ISSUE:	Certificate of Appropriateness for alterations
APPLICANT:	Elizabeth Gorman
LOCATION:	Old and Historic Alexandria District 400 Wolfe Street
ZONE:	RM/Townhouse zone.

Docket #5 BAR #2022-00495 Old and Historic Alexandria District January 18, 2023

The applicant requests a Certificate of Appropriateness for the replacement of existing wood siding with the proposed siding on a portion of the south elevation.

# ARTISAN® V-GROOVE SIDING

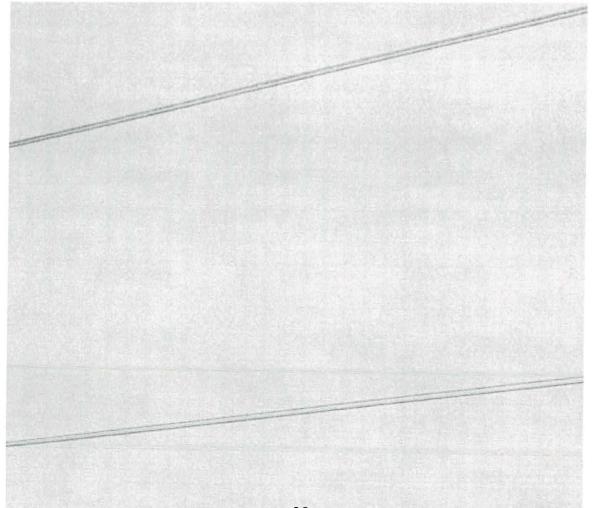
Steve Milone, 907 Prince Street, expressed concern regarding the use of fiber cement siding to replace the wood siding, noting that current siding has a unique profile. He further asked the Board that if they choose to allow the replacement, to require an exposure that is more similar to that of the existing.

Mr. Adams noted that wood siding located adjacent to the property line is a condition that exists throughout the historic district and that the approval of the use of fiber cement in this location could be a precedent. He also noted that the existing profile is one found throughout the district and that replacement wood siding to match the existing could be acquired.

Mr. Adams noted that the guidelines specifically do not allow the use of fiber cement siding on structures within the historic district and did not support this as an exception.

One concern the Board expressed during the December 7 meeting was that the profile of the Hardiplank siding I was requesting permission to use on the south side of the house was not consistent with the current wood siding. After more research, it looks like this Truexterior product has more profile options and the cove/dutch lap design is closer to the existing siding. As such, I am amending my application to specify the use of the Truexterior product (cove/dutch lap profile) instead of Hardiplank.
